**Re: Opposition to Proposed WADC Wastewater Discharge to Lick Creek**

The WADC recently submitted a National Pollutant Discharge Elimination System ("NPDES") application to the TDEC Division of Water Resources ("DWR") for a new discharge of treated sewage wastewater to Lick Creek near Mile 10.3 in Hickman County. Along with the permit application materials, WADC submitted their Preliminary Engineering Report ("PER"), our review of which guides the basis for the following analysis of why TDEC should deny WADC's request for a permit.<sup>1</sup>

**FIGURE 2**  
**PROJECTED FUTURE SEWER SERVICE AREAS**  
**75-YEAR PLANNING PERIOD**

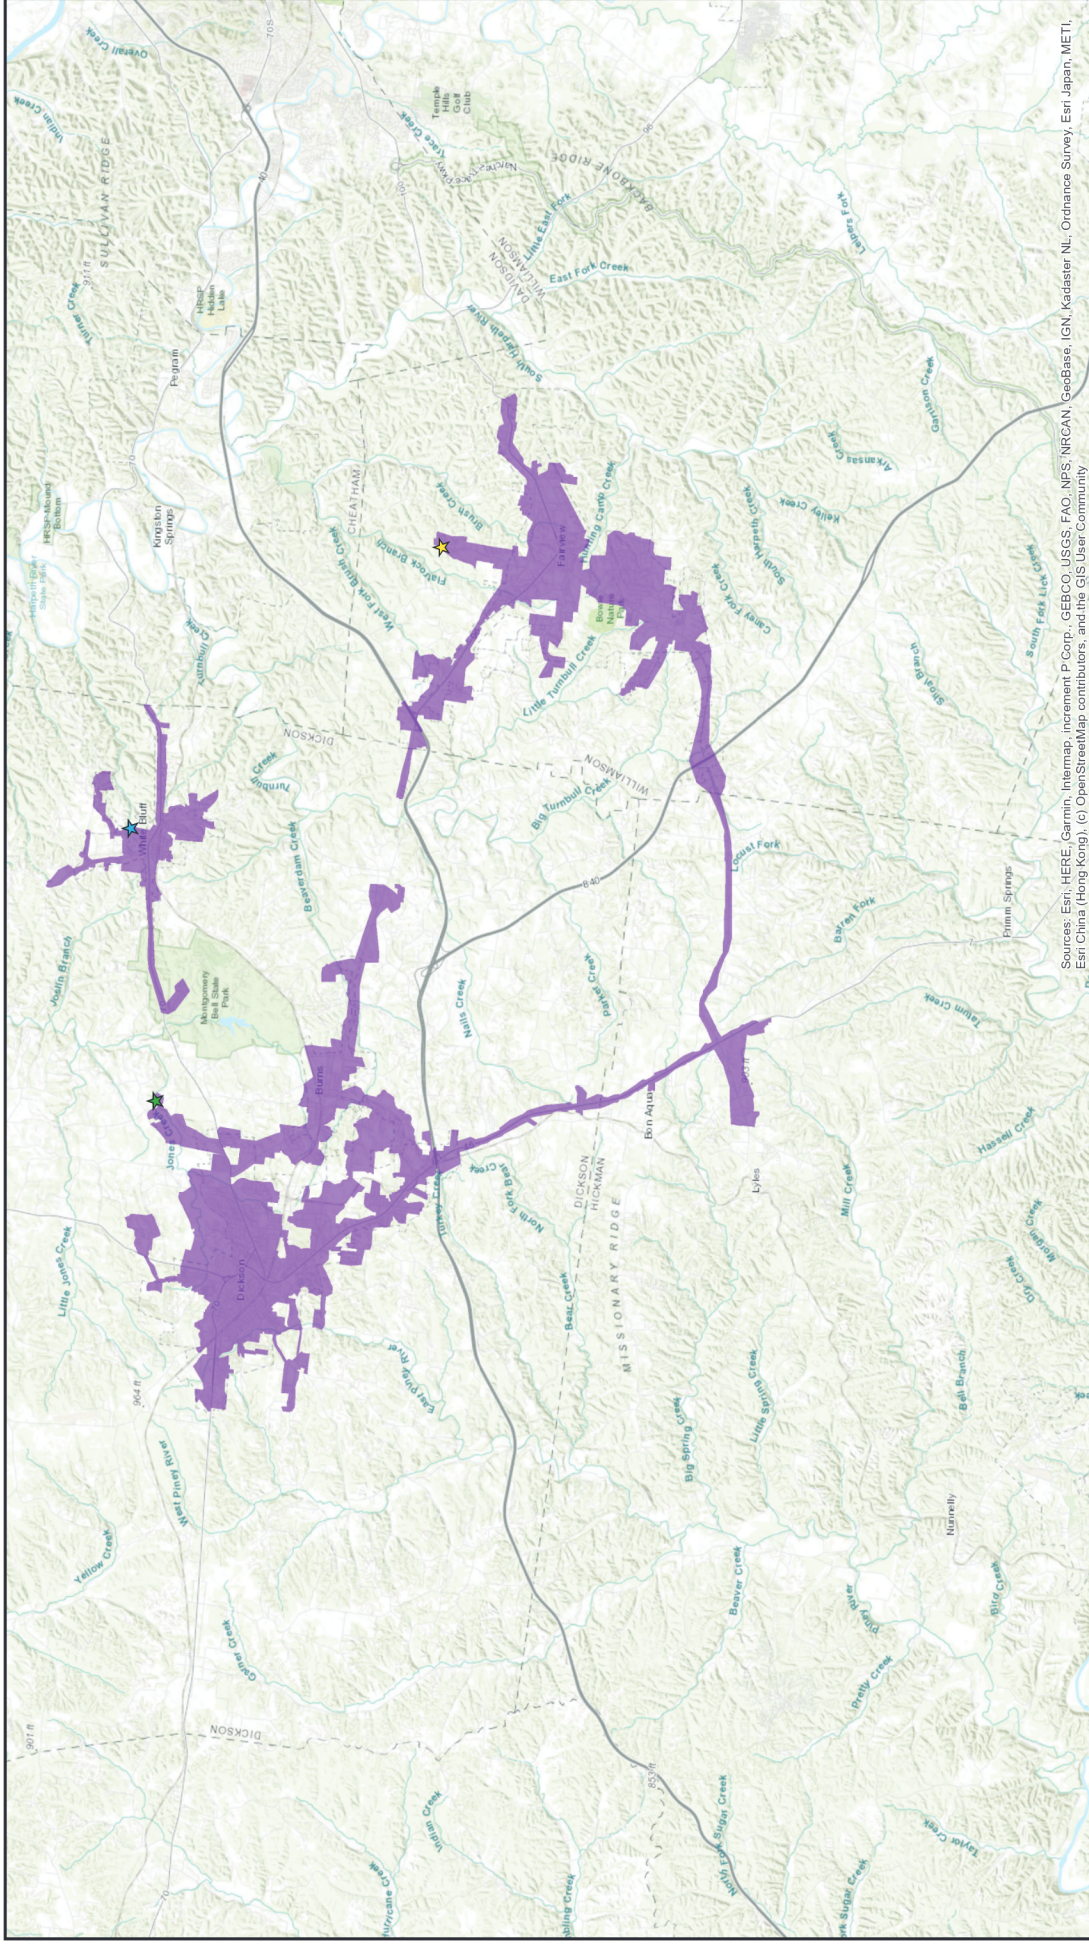
The area in which the discharge point is located is not within the 75-year planned service area of WADC’s new system as demonstrated by its PER. (**Attached hereto as Figure 1**).<sup>3</sup> Rather, the proposed discharge location is approximately 8 miles away from the service area boundary. Furthermore, the 75-year planned service area for WADC does not include the Lick Creek Watershed according to its own PER. WADC notes, “[i]t is anticipated that most of the growth will occur within the City of Dickson, the City of Fairview, and the area bounded by Interstate 40, Highway 46, Interstate 840, and Highway 100.”<sup>4</sup> This area is nowhere near the discharge point and clearly not inside the Lick Creek watershed. (**Figure 2**).

Thus, based on the two most practical, common-sense definitions of “the area in which the waters are located,” WADC has not and cannot demonstrate that the proposed degradation is necessary to accommodate important social or economic development in the area in which the waters are located.

Figure 2. Overview of Existing and Proposed Expansion of WADC Wastewater Treatment System (Lick Creek Watershed Denoted in Orange Boundary) Dickson, Hickman, and Williamson Counties Tennessee

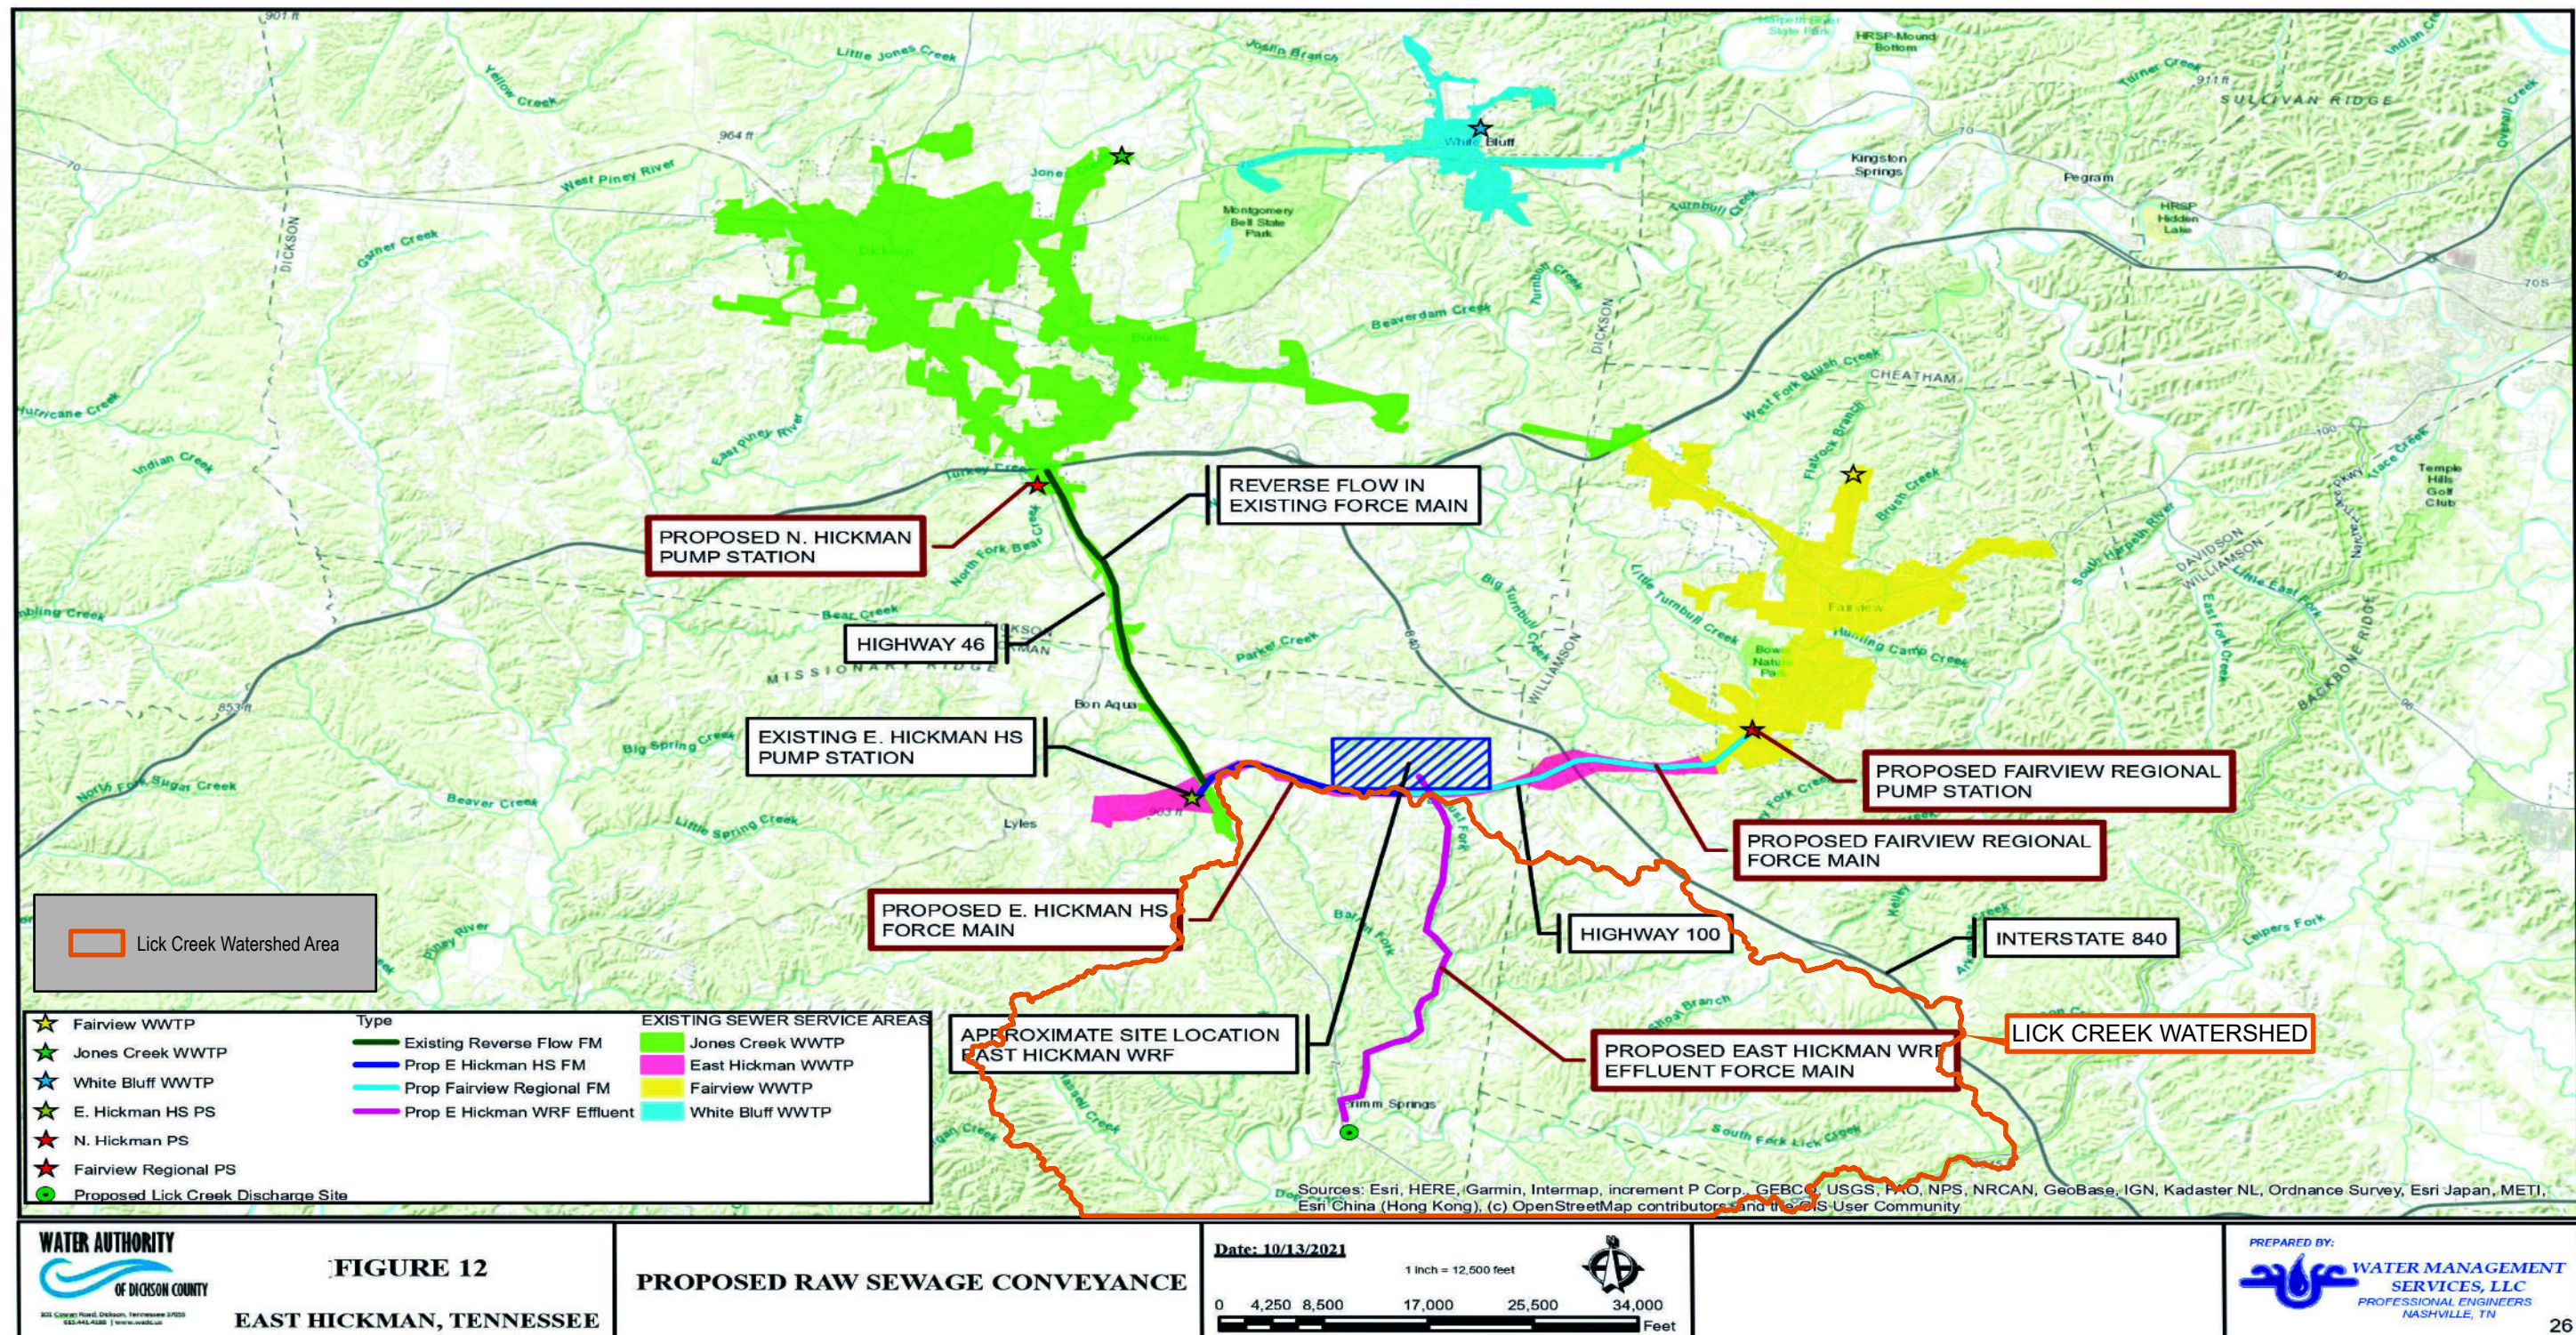
It is important to note that the proposed new treatment plant in Hickman County and its discharge to Lick Creek are primarily intended to accommodate existing and projected capacity needed by Dickson and Williamson Counties (chiefly, the Dickson and Fairview communities, but also, more distant communities such as Burns and White Bluff). The estimated additional capacity needed to serve Hickman County is substantially less than the aggregate of the other served communities and includes the speculative demand from a hypothetical “large wet industry” that may someday locate in Hickman County. Accordingly, most of the additional projected capacity of the proposed WADC expansion, and its related discharge to Lick Creek, will benefit areas other than Hickman County, and certainly not areas within the Lick Creek watershed.

**Figure 3. Proposed WADC East Hickman Water Reclamation Facility and Outfall Proposed WADC Wastewater System Expansion  
Dickson, Hickman, and Williamson Counties  
Tennessee**

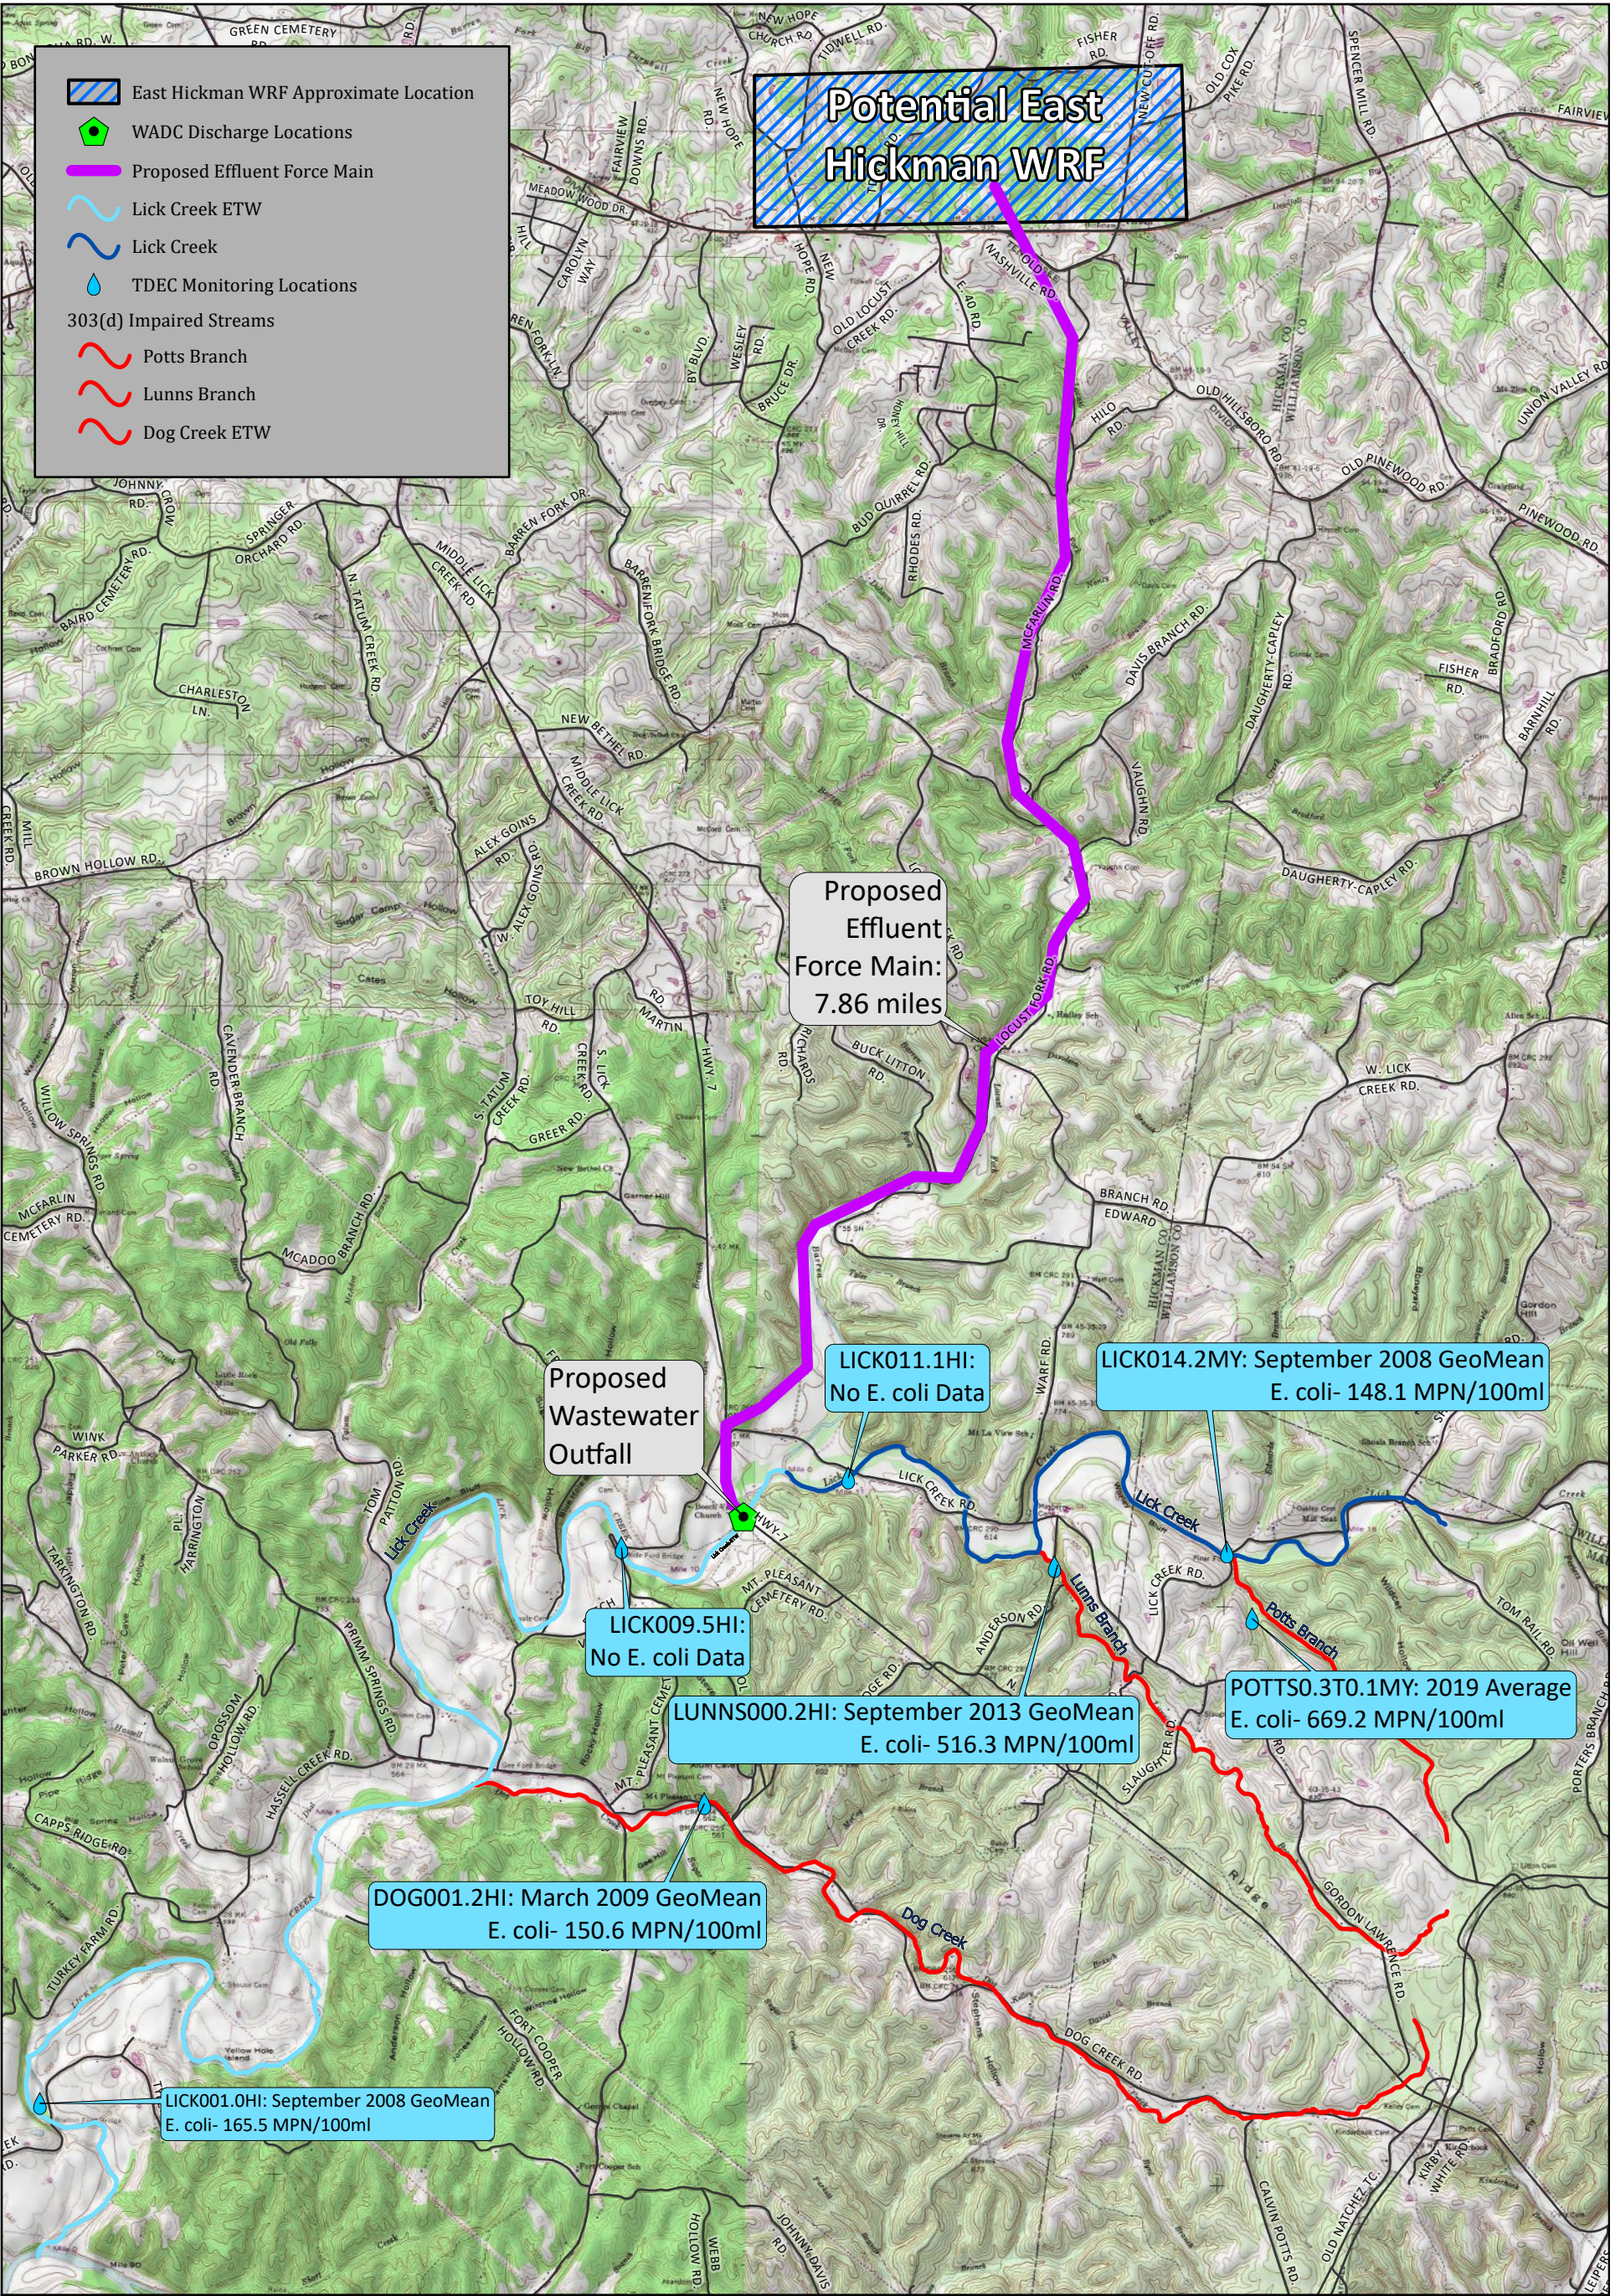
Downstream of the WADC's proposed outfall location, Lick Creek receives flows from tributaries that are impaired by *Escherichia coli*, resulting from ubiquitous and intensive livestock production in the Lick Creek watershed **(Figure 3)**. TDEC has documented that *E. coli*

concentrations in Lick Creek, both upstream and downstream of the proposed WADC outfall discharge, at times exceed the water quality criterion for recreation. During these conditions of high *E. coli* concentrations in Lick Creek, no assimilative capacity is available for additional *E. coli* loads.
